FINAL PLAT

WOODLAND LAKES ESTATES THIRD ADDITION

RE: SUB 2002-79 -- Final Plat of Woodland Lakes Estates Third Addition

At the regular meeting of the Subdivision Committee of the Metropolitan Area Planning Commission on Thursday, September 19, 2002, the above captioned plat was considered. The action of the Committee was to approve the final plat, subject to the following:

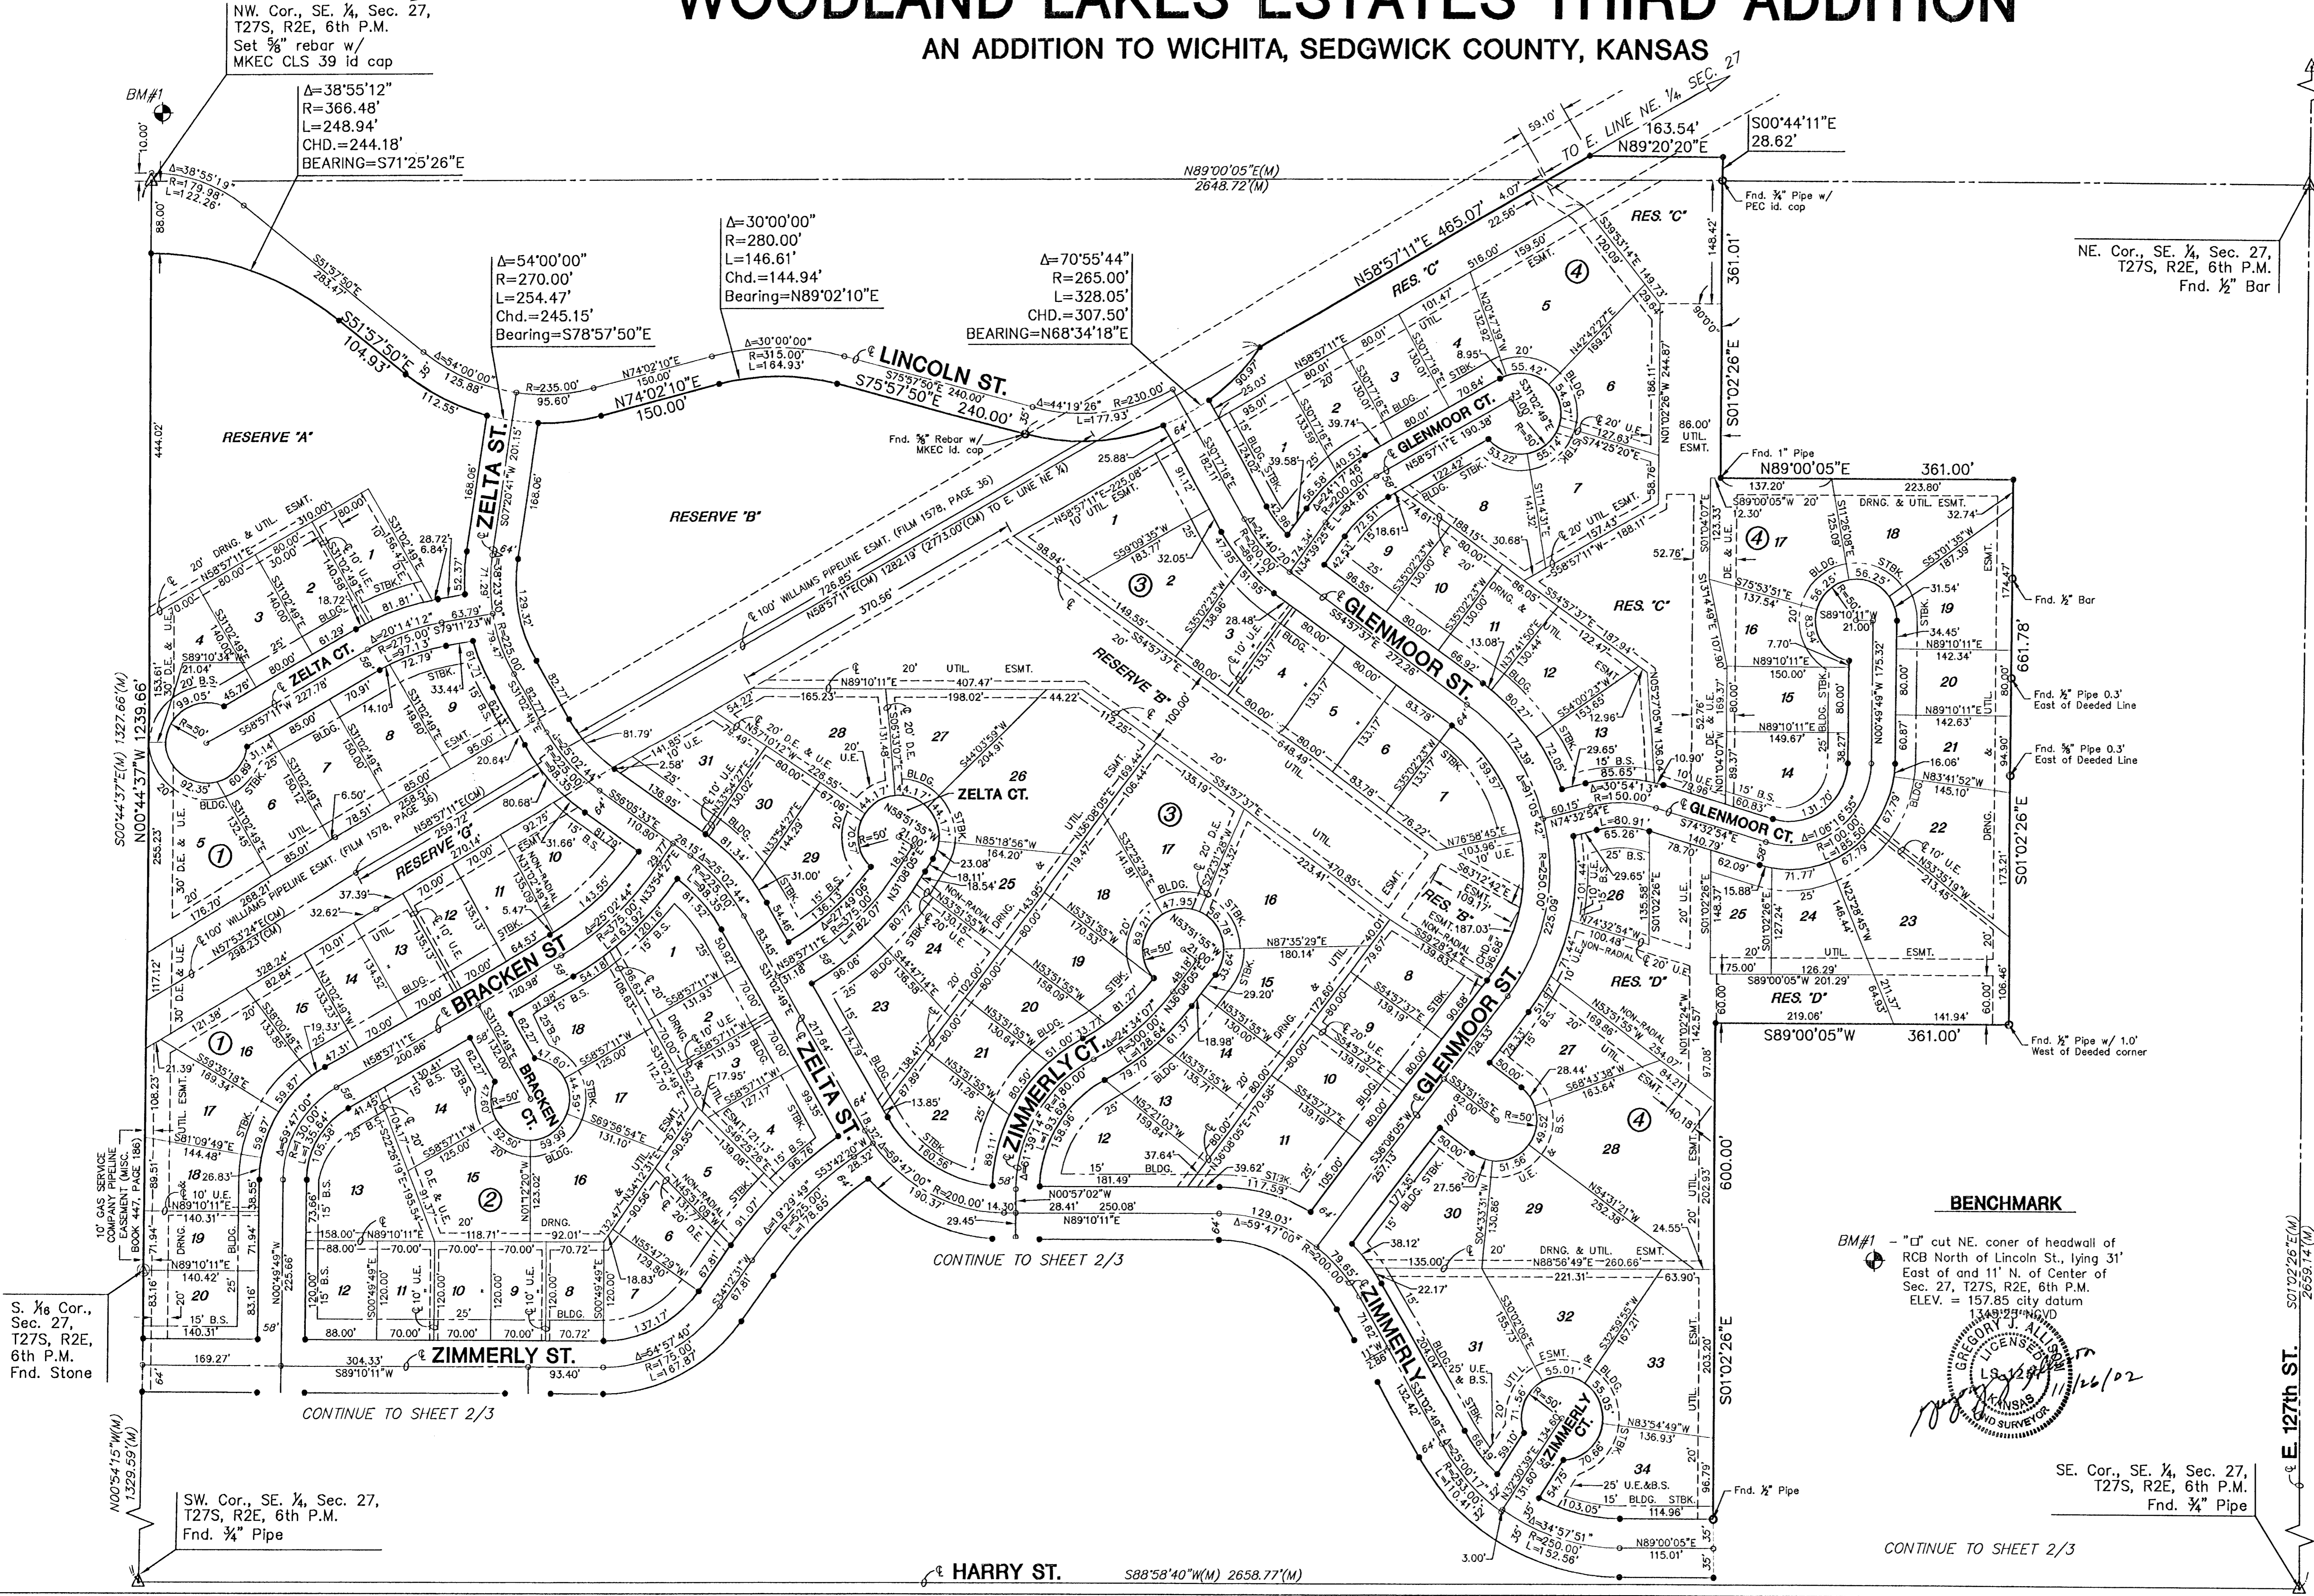
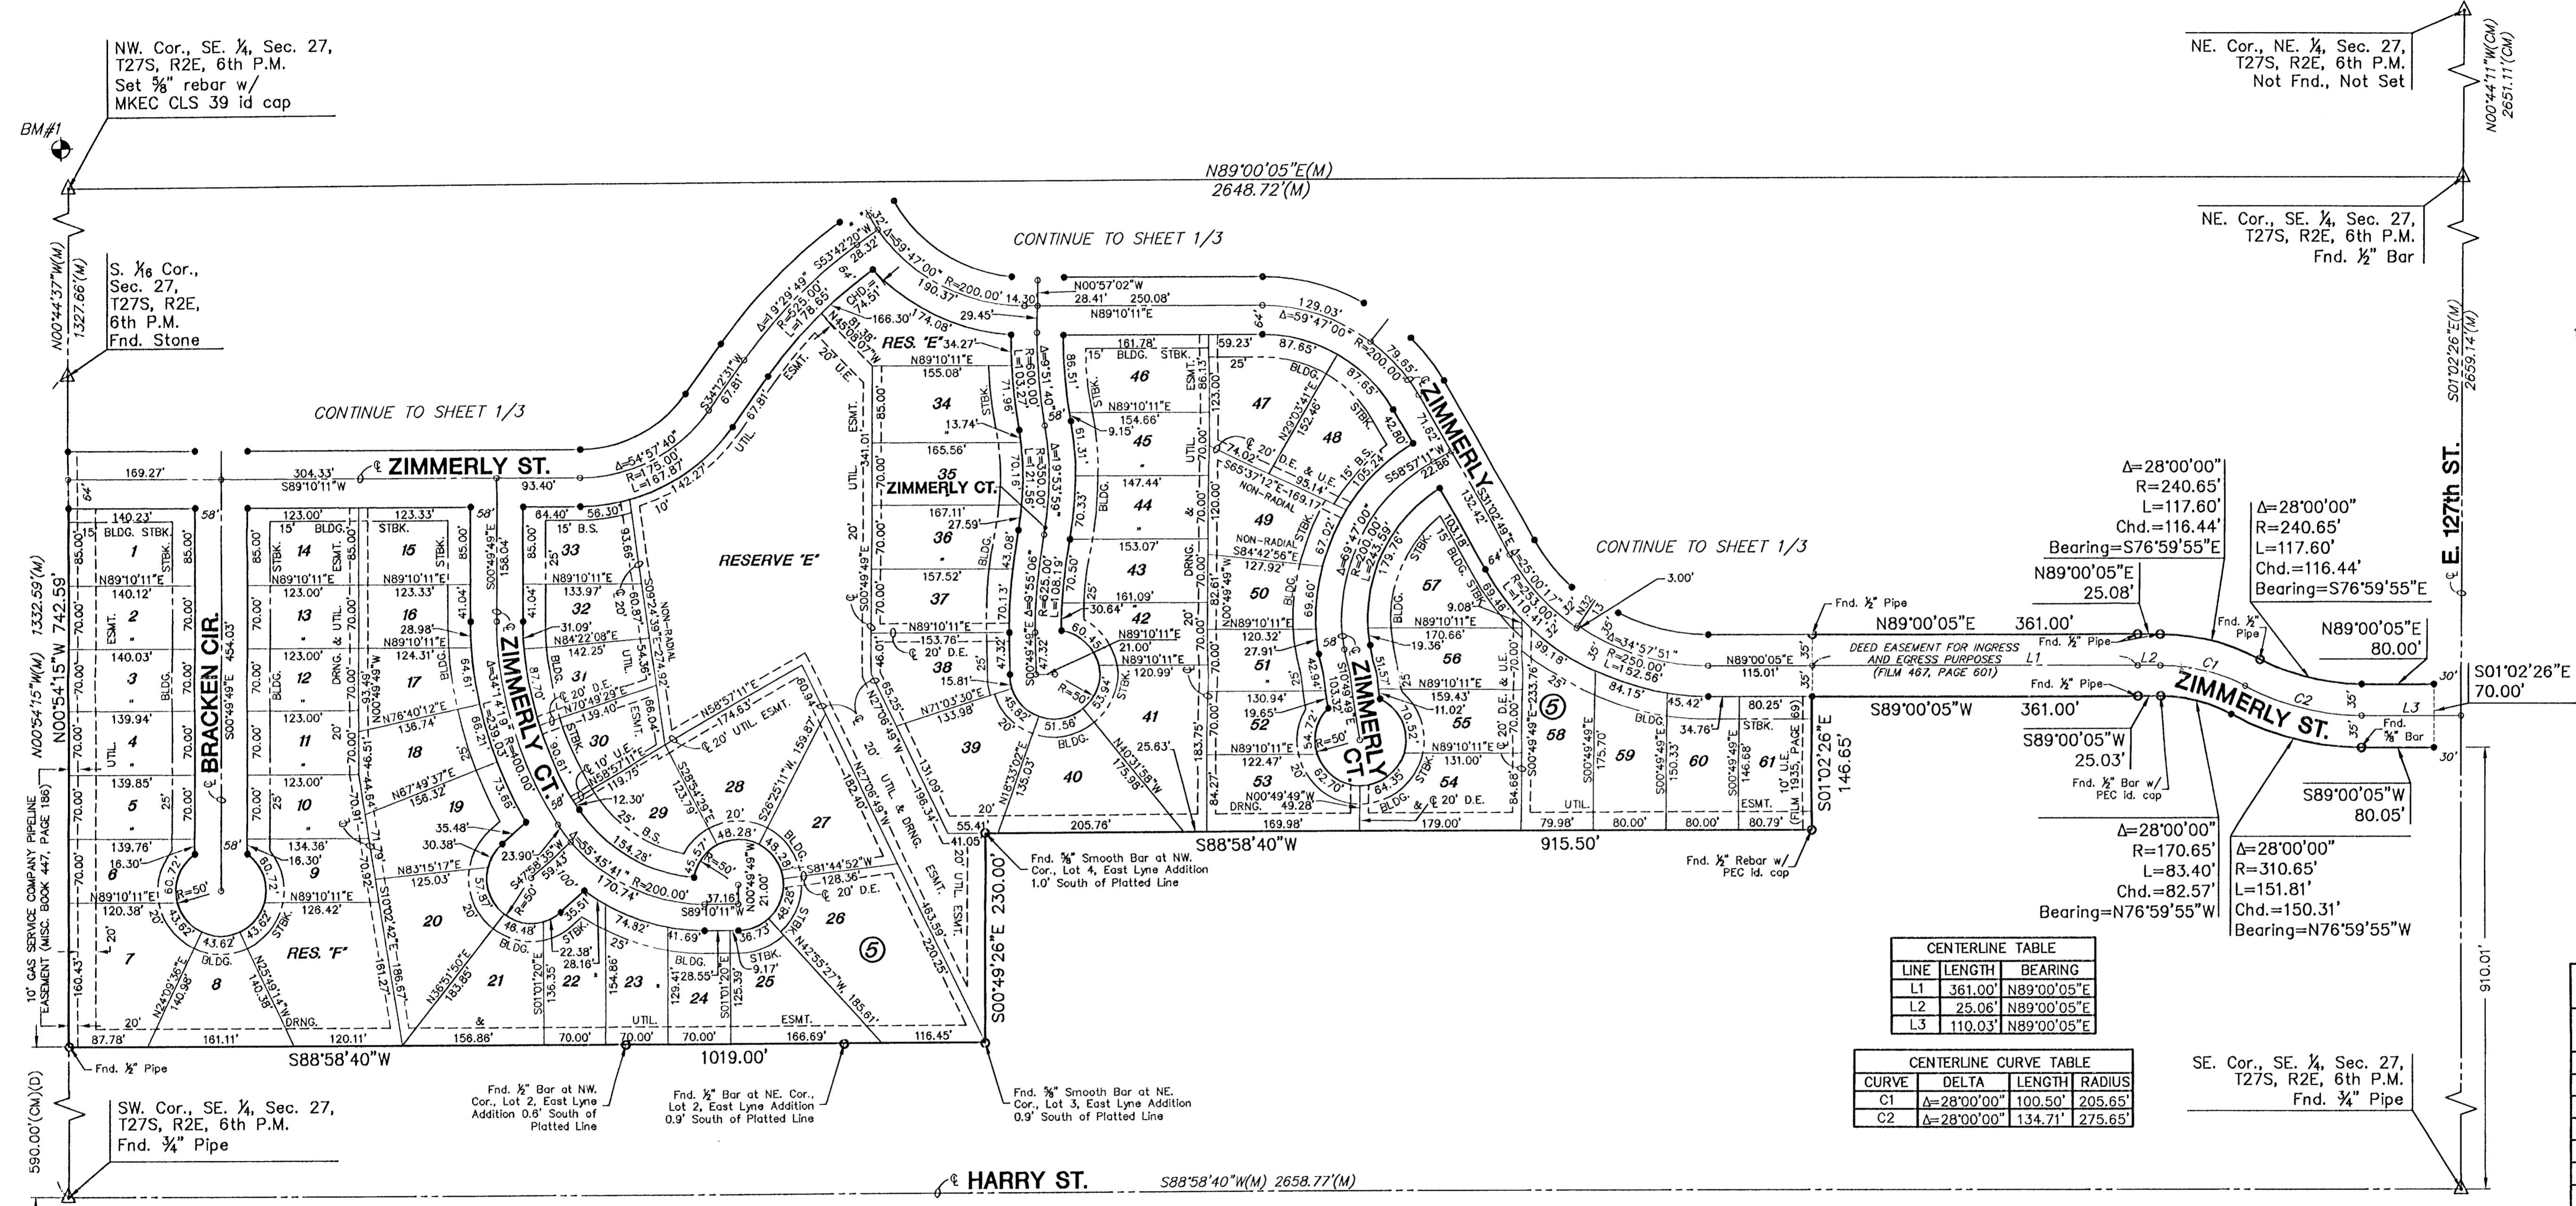
- C. The platting of minimum building elevations should be noted on the final plat tracing.
- D. City Engineering needs to comment on the status of the applicant's drainage plan. Off-site drainage easements are needed along with a drainage guarantee. A revised drainage plan shall be submitted prior to MAPC meeting. A lot grading plan is also needed. Reserve E shall be expanded to include Lots 34 and 35.

- E. The Applicant shall guarantee the paving of the proposed streets.
- F. The south segment of Glenmoor needs to be labeled as a 64-ft right-of-way.
- G. Left turn lanes along 127th St. East are needed contingent upon future traffic volumes.

- P. The applicant has platted 20-ft building setbacks for the lots abutting the terminus of the cul-de-sacs; whereas the Zoning Code requires 25 feet. The Subdivision Regulations permit the setback provisions to be modified by the plat upon the approval of the Planning Commission. *The Subdivision Committee recommends approval of the setback modification.*
